## 2.2.6 AMENDMENT 16: CPH

### Glazed gate heights aligned with adjacent doors & glazed overpanel added

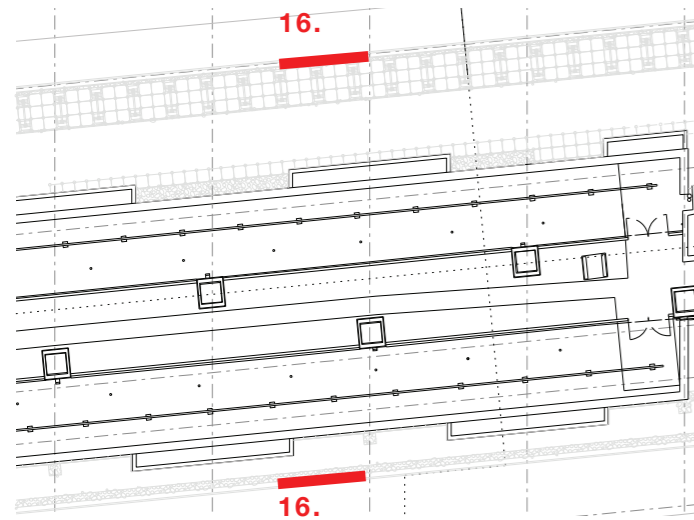
After detailed elevations were developed it was felt that the full height glazed gates to the East-West pedestrian link were at odds with the visual line of the glazed entrance doors elsewhere on the facade.

Further discussion with glazing suppliers also confirmed that full height doors would be technically difficult to achieve and would require a large portal frame to carry their weight. This frame would be highly visible on the West elevation and would be detrimental to the concept of a flush glazed facade.

It is therefore proposed to reduce the height of these to align with the adjacent retail door heights and provide a fixed glazed overpanel up to the underside of the soffit. This reduction in size will allow the frame to be minimised, retain the flush principle of the facade and provide a consistent visual line. It will also benefit by providing a clearer, permanent area for pedestrian signage on the static overpanel above, which is not currently provided by full height opening gates.
